STAFF REPORT: 4/13/2022 MEETING

APPLICATION NUMBER: #22-7746, #22-7747

ADDRESS: 1127-1135 VINEWOOD

SCOPE: REPLACE GARAGE DOOR, INSTALL SIDING ON DORMER, REPLACE PAVING, INSTALL FENCING/LANDSCAPE

Site Photo 5, by applicant: (Southwest) rear elevation, showing new dormer.

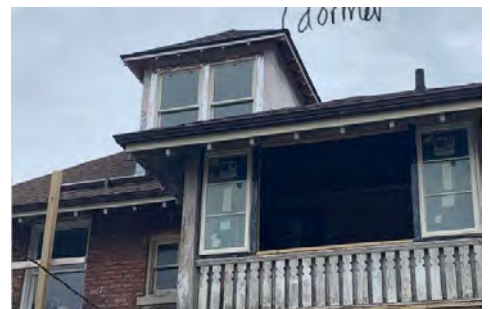
- The proposed garage door, in staff’s opinion, does not closely resemble the existing doors in their design, materiality or scale.
- Staff has confirmed that the October 2020, HDC COA did call for a material for the new rear dormer to match the existing dormer in material, which has slate siding. It is staff’s opinion that the proposal to change the material from slate to grey Hardie board for the newly constructed rear dormer, which is not within public view from the front, would be appropriate. While the applicant has offered a choice between green and grey, it is Staff’s opinion that matching the grey color with the Hardie Shingle Siding “gray slate” as proposed would be appropriate. Staff offers the opinion that the shade of grey should be adjusted to a darker shade to match the existing slate color of the house more closely. (See product detail image 1 and Site photo 7.)

- Staff has no issue with the proposed installation of Hardie board siding for the rear dormer. Staff offers the opinion that the color should match the existing grey slate of the existing dormers.

- The Hardie board siding be of a color that approximates the existing slate siding of the dormers.
- Staff receive a final landscape plan showing the location and species of proposed trees.
- The applicant provide HDC staff a review of the above items before installation.

Landscape Plan from Applicant, showing locations of proposed pavers, property fence (red), dog run fence location (blue) and rear landscape plantings and firepit.

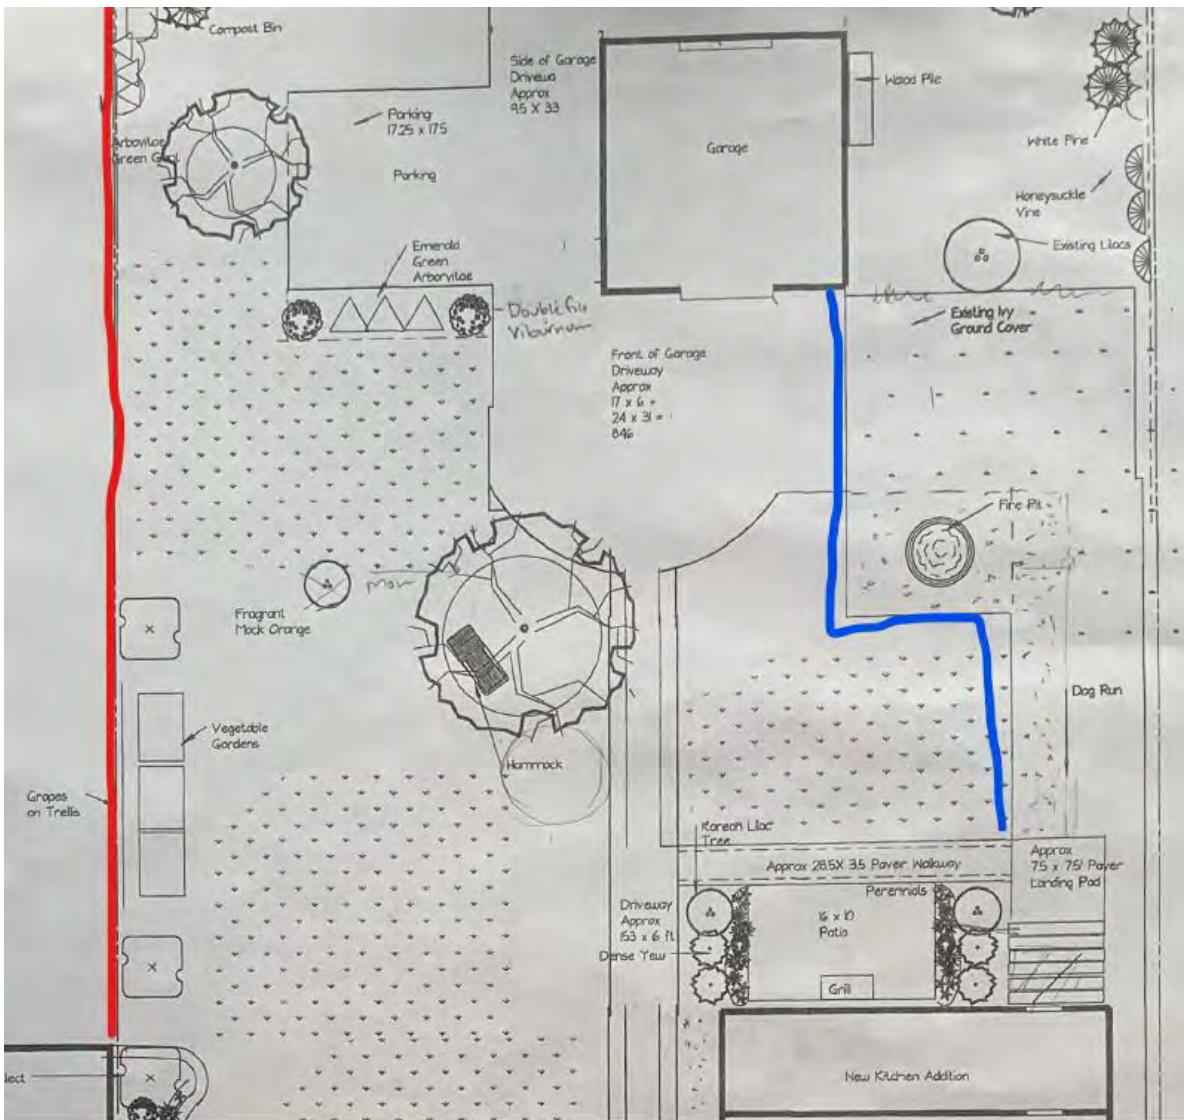
- Staff observed that the two-track concrete driveway had lawn as the median in preceding images, but today there are some pavers set in the median. It is staff’s opinion that neither the driveway nor these added pavers are historic character-defining features of the property.

- The proposed pavers for the driveway and patio are both colored-concrete pavers by Techo-Bloc.
- The proposed driveway pavers, “Pure” have a wide color range from chestnut brown to shale grey. The applicant has not specified the color, by the date of this report. It is staff’s opinion that these pavers for the front yard introduces yet another new material that detracts from the historic elements already found on the property: dark and tan brick, dark slate, concrete, wood, and cast stone. The Elements of Design for Hubbard Farms describe *Relationship of Colors*, *Relationship of Architectural Details*, and *Relationship of Significant Landscape Features and Surface Treatments*:

Staff offers the opinion that an appropriate material for the proposed driveway would be one that matches the existing front walk or matches materials of the house’s exterior brick or stone.

- For the rear of the property, from the side of the house to the rear, staff offers the opinion that the proposed pavers would be appropriate use as shown in the attached drawings.
- The proposed 4’ dog fence is made of vinyl.
- Staff has observed that the proposed tree, “Cleveland Pear” (*Pyrus calleryana*) is considered an invasive species.
- Staff offers the opinion that the 6’ high wood panel fence, the pea gravel around the fire pit and the proposed landscaping are consistent with the scale, design and material of the historic character of the property.

- Staff has no issue with the proposed replacement of the front walk with concrete.
- It is staff’s opinion that the replacement of the front yard portion of the driveway with the proposed concrete pavers introduces a new material that would alter the historic character of the property and therefore destroys the original scale, design and materiality of this historic property, and therefore does not meet the Secretary of Standards for Rehabilitation.

- Staff has no issue with the use of the proposed pavers for the rear side of the property.
- Vinyl is not an appropriate material for fencing in Hubbard Farms HD, therefore the 4’ dog fence as proposed would not be appropriate for this site. Other materials and products should be available for this purpose.

- Other than the proposed tree, “Cleveland Pear” (*Pyrus calleryana*) which is considered an invasive species, staff has no issues with the 6’ wood panel fence, the pea gravel around the fire pit and the proposed plantings in the landscape plan.
